**From:** Kerrie Symonds  
**Sent:** 12/02/2022 10:57:02 AM  
**To:** Council Northernbeaches Mailbox  
**Subject:** DA2021/2644 1 Tasman Rd, Avalon Beach Attn Adam Mitchell  
**Attachments:** 220207 Submission 1 Tasman Rd Avalon.pdf;

**DA2021/2644, Lot C DP 102027, 1 Tasman Road Avalon Beach**

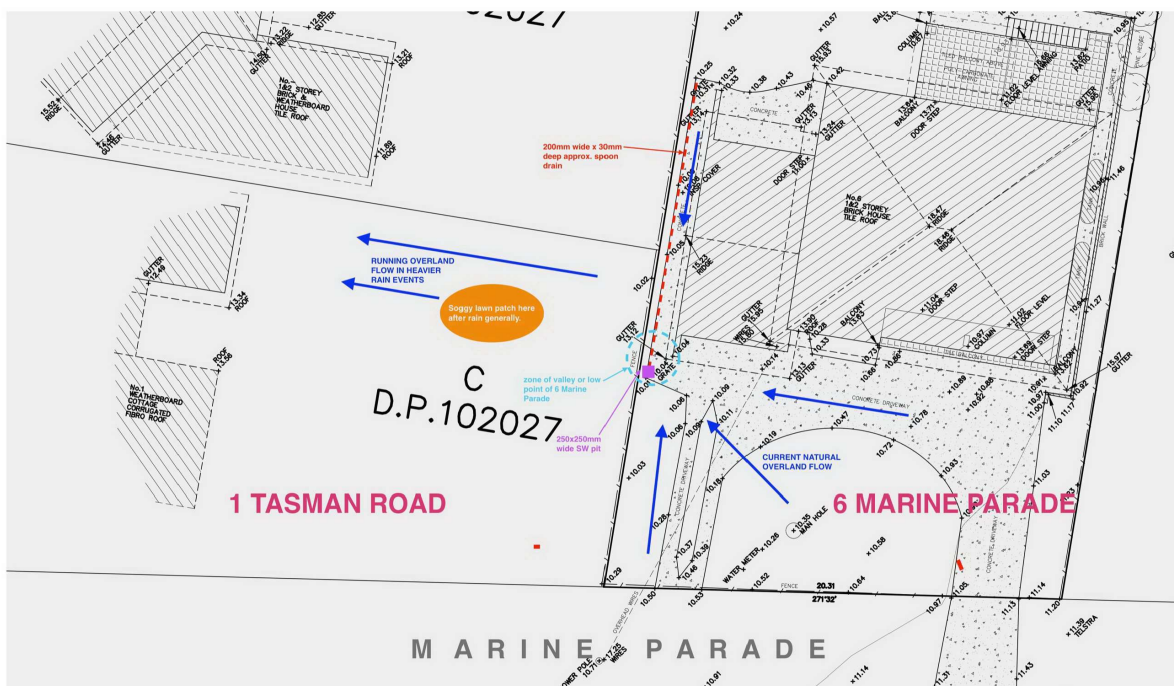
During rain periods, an overland flow path crosses our property, from our property and from properties to the east, flowing to the west under and through the existing timber fence. This flow path is shown in the diagram below, prepared by the applicant's architect. The flow path does impact No.1 Tasman Road, with a running overland flow and soggy lawn during heavier rain events. This is also the location of flood risk, identified on Council's Flood Maps.
